Product Change Notification

NOTIFICATION NO.	ISSUE DATE	LAST BUY DATE	LAST SHIP DATE
EU-PCN-20220301-01 Rev.2	06.10.2022	---	---

Distance Measuring Sensors - please see the attached model list

Comparison sheet related on material change for SHARP Distance sensor

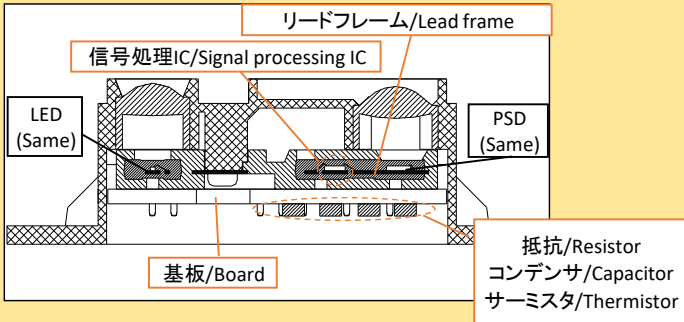
変更前/Before Change	変更後/After Change
社外品番/Applicable Model No.			全機種/All models (Same)	
社内品番/SHARP Internal Model No.			添付リスト参照/Refer to attached list	変更予定/Will be changed
Country of Origin / Manufacturing Location			中国／珠海縁成電子 China / Zhuhai Ense Electronics Co., Ltd. (Same)	
材料/ Materials	信号処理IC /Signal processing IC	工場/Factory	On Semiconductor	UMC
		IC仕様 /IC Spec.	→	端子配置・機能変更有り /Pin assign・Function changed
		開発・ベンダー / Design・Vendor	S company (同一/Same)	
	基板/Board		→	ICに合わせた配線パターン変更 /Layout pattern changed to fit new IC
	抵抗/Resistor		→	ICに合わせた定数変更・使用数変更 /Constant value and use number changed to fit new IC
	コンデンサ/Capacitor		→	ICに合わせた定数変更・使用数変更 /Constant value and use number changed to fit new IC
	サーミスタ/Thermistor		→	ICに合わせた定数変更/Constant value changed to fit new IC (一部機種のみ / Only some models)
	リードフレーム/Lead frame		→	ICに合わせたフレーム変更 / Frame changed to fit new IC (一部機種のみ / Only some models)
	断面図/Cross section (参考/Reference)

その他部材(LED, PSD, Lens付きモールドケース等) /The other materials(LED, PSD, Lens mold case, etc.)		同一/Same	
電気的特性 / Electronic spec. (絶対最大定格含む/ Including absolute maximum rating.)			同一/Same	
QC工程 / QC process			同一/Same	
製品信頼性 / Product Reliability			同一/Same	
外形図/ Outline Dimension			同一/Same	
マーク/ Marking			→	末尾に識別マーク付加 / Discrimination mark will be added at the end
梱包仕様 / Package spec			同一/Same
